DEVELOPMENT SERVICES –LANDSCAPE RESPONSE FORM

TO: Deborah Smith	DATE: 1 st November 2018
REF: 17/04151/FUL CD.1580/1/D	
Address: Land Parcel At Upper Rissington Upper Rissington Gloucestershire GL54 2NP	
Proposal: Variation of condition 1 of reserved matters permission 12/03810/REM dated 23/01/2013 to provide detailed plans and sections of open space provision and to provide amended plans for hard surfacing and planting

Hard Surfacing 5 of 7 (5109/ HS16 Rev. Q)

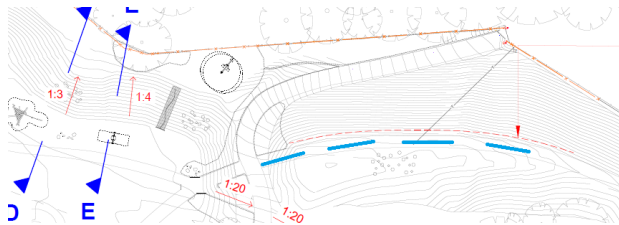
- *A bin should be included on the path adjacent to the LAP. – DONE*

Amenity Play 1 of 3 Planting Plan (5109/PP01 Rev. N)

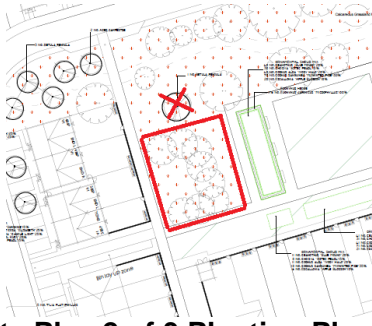
- *Introduce bulb planting beneath the Fagus sylvatica 'Purpurea' tree avenue. - DONE*
- *A group of existing trees to the north of the officers mess have been removed. This must be reflected on the plan along with new replacement trees. I would recommend that the proposed birch is omitted and new tree avenue of introduced alongside the path. Given the proximity of housing I would recommend a small/medium tree species such as Pyrus calleryana 'Chanticleer' and an extended area of amenity grass. – DONE.*
- *The five a side football pitches have been added.*
- *The bowling green label has been added.*

Amenity Play 2 of 3 Planting Plan (5109/PP02 Rev. N)

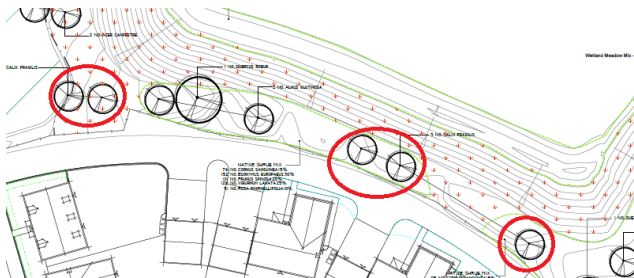
- *Introduce bulb planting beneath the Tilia platyphyllos tree avenue along the footway.*
- DONE
- *Will the basin have a liner? If not it is advised that this area is seeded with a wetland meadow mix.* – Details of this have been provided.
- *The use of willow adjacent to the carriageway could cause future maintenance problems. The 5 no. willow as shown on the plan below should be substituted for alternative species such as Acer campestre, Alnus glutinosa and/or Sorbus aria.* – DONE.

Amenity Play 3 of 3 Planting Plan (5109/PP03 Rev. N)

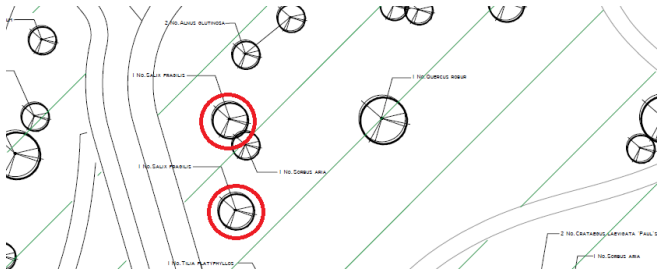
- *For reasons above update 2 no. willow with alternative native species.* – DONE.

Trim Trail (5109/PS.ASP06 REV. A)

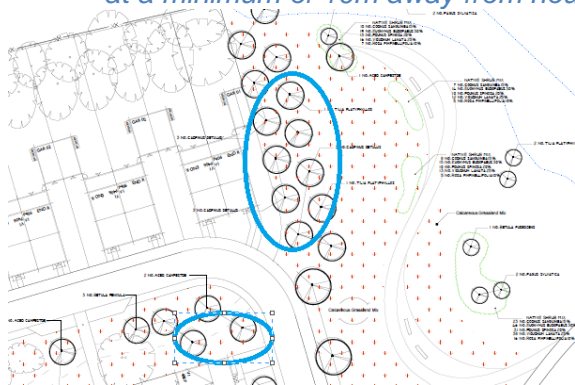
- *The equipment specified is for children only. Should this also cater for adults?* – Equipment for adults has been added to the trim trail which is welcomed.

Country Park 1 of 2 Planting Plan (5109/PP06 Rev. N)

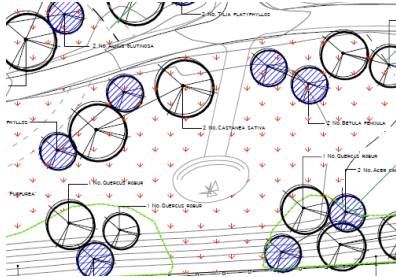
- *The use of poplars is not recommended as these trees can become a future maintenance problem. It is advised that these are substituted for alternative native species. Small/medium trees should be selected where trees are situated near to housing.* – DONE
- *A post and rail fence should be included half way down the steep bank to create a safe environment for pedestrians using the footpath. This should correspond with drawing Hard Surfacing 7 of 7 (5109/ HS19 Rev. O).* – DONE
- *Any updates to NEAP 01 (5109/PS05 Rev. C) should also be reflected on this plan.* - DONE

Boundary Areas 2 of 2 Planting Plan (5109/PP09 Rev. N)

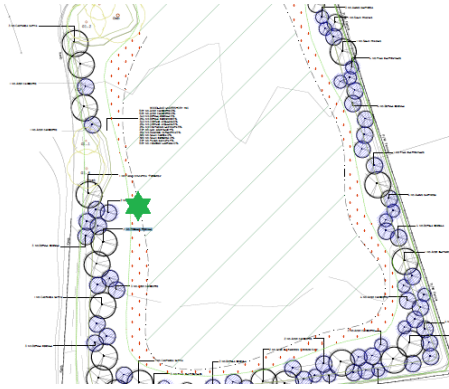
- Adjacent to housing - The mature height of *Tilia platyphyllos* will exceed 20m and should not be planted too close to housing. 3 no. should be omitted (see image below). – The 3 no. trees have been omitted.
